**WORCESTER COUNTY PLANNING COMMISSION AGENDA**

**Thursday November 2, 2023**

**III. 4 Seasons Townhome Community – Residential Planned Community - Step I Concept Plan**

**Approval requested:** Step I Residential Planned Community – Establishment of the RPC Floating Zone – 4 Seasons\* Townhome Community (**\*Name must be changed due to similarity with other projects of the same name within the County**)

PROJECT DATA

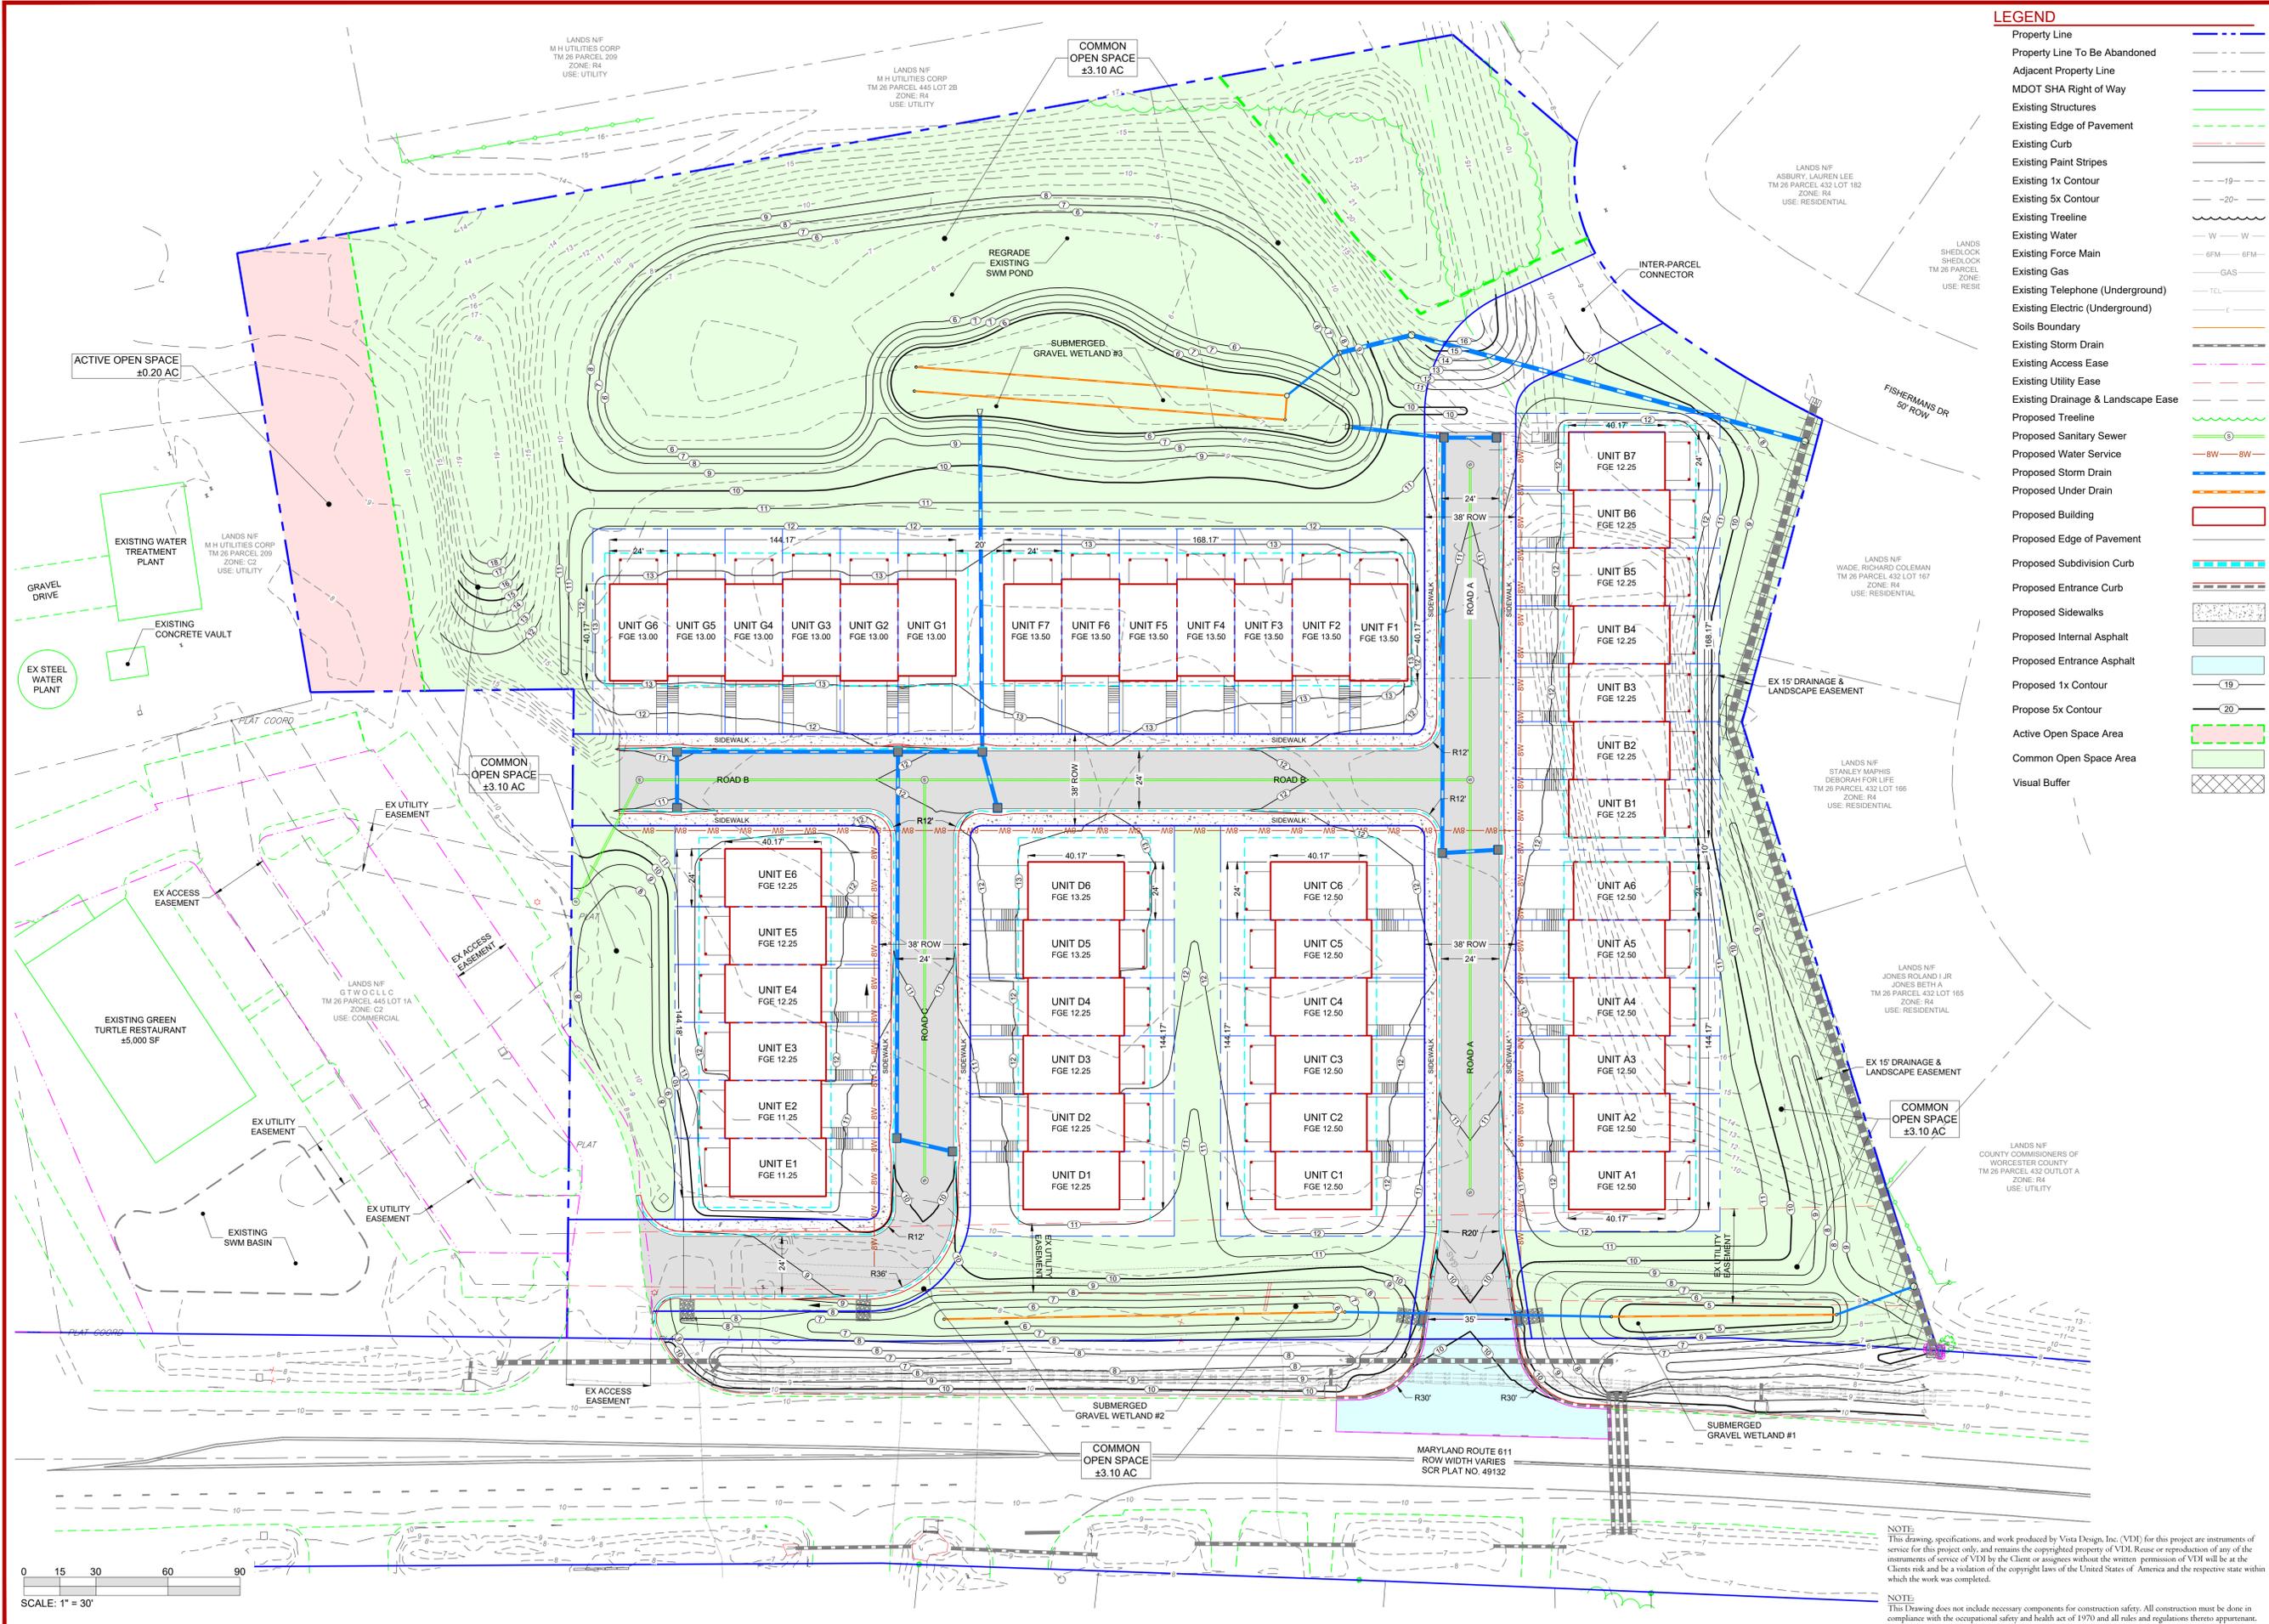
- The site plan shows the active recreation area in the northeastern most corner of the property. No equipment has been identified on the site plan to meet this standard. This will need to be provided prior to the submission of a preliminary plat or Step II master plan. Access to the active open space should also be shown. However, the proposed location of the active open space is not in close proximity to the units within the areas designed for both passive open space and stormwater facilities. Staff requests that site designers contemplate moving the active open space to the location directly south of the Green Turtle if possible, with appropriate measures included to protect children from accessing Stephen Decatur and the Green Turtle property during play such as fencing if children's play areas are anticipated.

A ‘visual buffer’ is proposed along the southernmost property lines which abut the Mystic Harbor subdivision. **Further information regarding this ‘buffer’ will need to be provided as part of the Step II master plan submission.**

Connectivity to main transportation networks are another feature of the proposed development that are consistent with the Comprehensive Plan. Access will be via two (2) commercial entrances onto MD Route 611 (Stephen Decatur Highway) for the residential uses. The northernmost entrance is an existing entrance/access easement which serves the Green Turtle restaurant and is not proposed for any additional improvements. An inter-parcel connector is provided via the internal subdivision roads of Mystic Harbour and an inter-parcel connector is addressed by function of the access easement to the Green Turle. The private roads are proposed to be constructed in accordance with Worcester County Road Standards and dedicated to the Homeowners Association. **For Step II, the site plan will need to indicate that the roads are proposed to be private.**

- b) Pending easement is to be submitted to the Water/Wastewater Division.
- III 4 Seasons Townhome Community
- a) Denote on plans that the roadways will be private roads.

- b) Please show all fire hydrants and valves for the water main.
  - c) Please use as-built drawing available at Ocean Pines WWTP upon request.
  - d) Please add a detail showing connection of water meter to 16" Water Main (Transite).

- e) Please add existing water main size to the existing drawings.
  - f) Please include the existing storm drain along the frontage of the property as it is used for the backwash outfall.

- g) Please provide a profile view of all proposed water and sewer utilities to be installed.
- IV Cathell, LLC – Minor Site Plan Review
- a) No comments from Public Works at this time.
